ADDENDUM NO. 1
INSTALL SOLAR RENEWABLE ENERGY SYSTEM AT BUILDING 001,
PUUNENE, MAUI, STATE OF HAWAII, DEPARTMENT OF DEFENSE,
HAWAII ARMY NATIONAL GUARD, JOB NO. CA-1121-C

The following are questions from the site visit that was held on June 22, 2017.

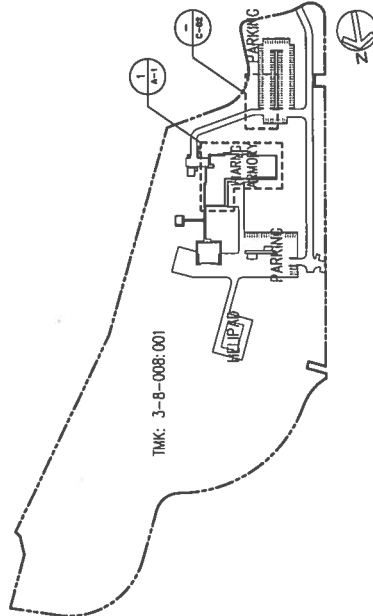
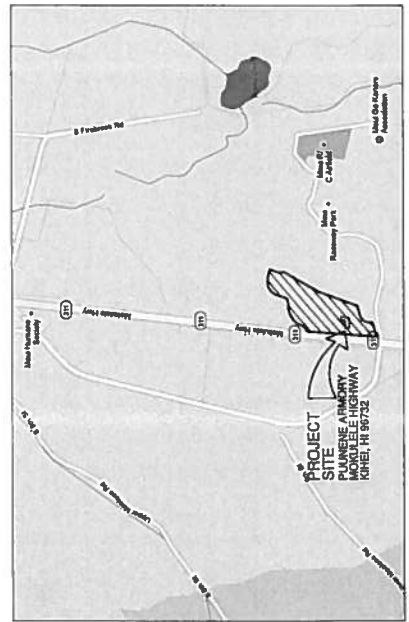
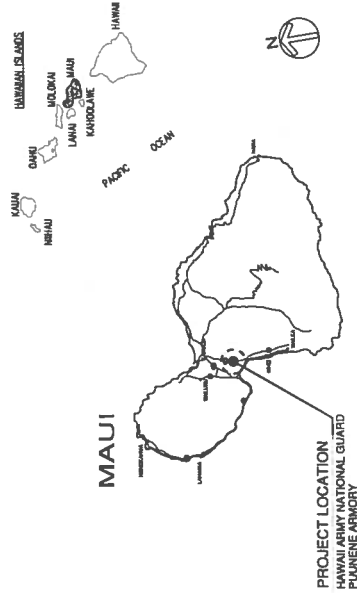
33. Our company is interested in responding but our contractor's license for the state of Hawaii is pending approval. Will you accept our response with a pending status on our contractor's license?
- a. Yes, no company is prohibited from bidding.
34. If the high bay roof is not used for PV panels, can the roof ladder be eliminated?
- a. Include roof ladder as well as new water line and hose bib at roof in bid. See note on Sht. A-1 to tap water line and extend to roof. See also revised Sht. A-3 indicating extent of water line and hose bib.
35. General Note No. 15 on Sht. T-1 indicates this project does not involve accessibility requirements. However, charging station stall is marked for ADA accessibility.
- a. Note No. 15 is revised to state: "This project conforms to the 2010 ADA Standards for Accessible Design."

Casting into New Concrete

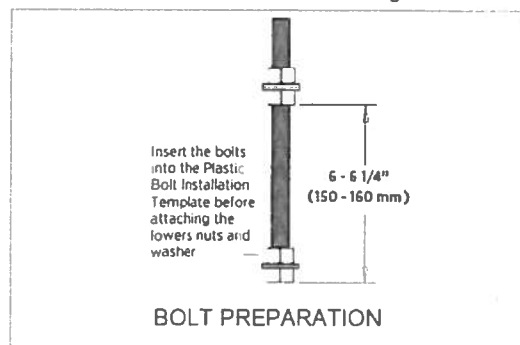
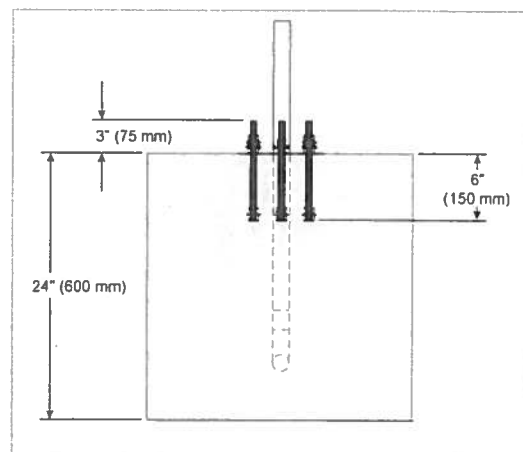
28. Please provide details for EV Charging Station Concrete Pedestal including size, concrete and rebar.
 - a. Installation instructions are provided by the Manufacturer. For the specified ChargePoint Charging Station, see attached detail from installation manual.

- Always check local codes to ensure compliance. You may need to adjust these instructions to comply with codes that apply at your installation location.
- The concrete block must measure at least 24" on all sides.
- The bolt threads must extend 3" above the concrete.
- The conduit must be at least 1 ½" in diameter and extend 12" to 24" above the concrete.
- Refer to the CT4000 Installation Guide for detailed installation instructions.

ELECTRIC USAGE PROFILE FOR METER MMX000126613

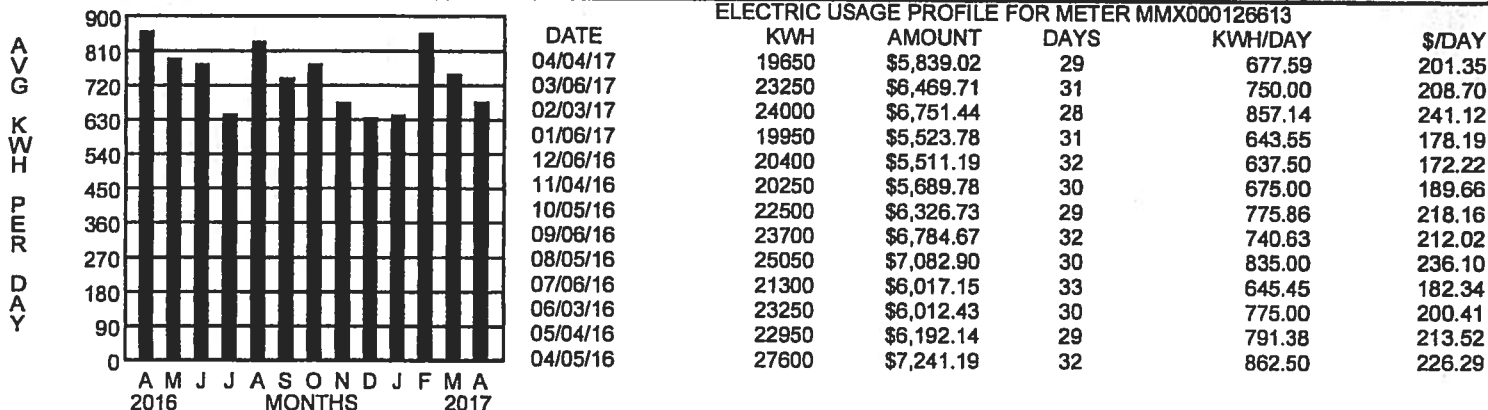
2. Please identify Maui Electric Meter to which proposed PV system should be grid connected. A copy of electric bill may also be provided.
 - a. See attached MECO bill for account 202010836080. Power usage noted on the invoice shall not have bearing on requirements established for this project.

25. Please confirm grid tie Meter No.126613.
 - a. See Response for item 2.
26. Please confirm Main Disconnect Breaker Rating on Switchgear.
 - a. Per AS-BUILT drawings: 3P800A.
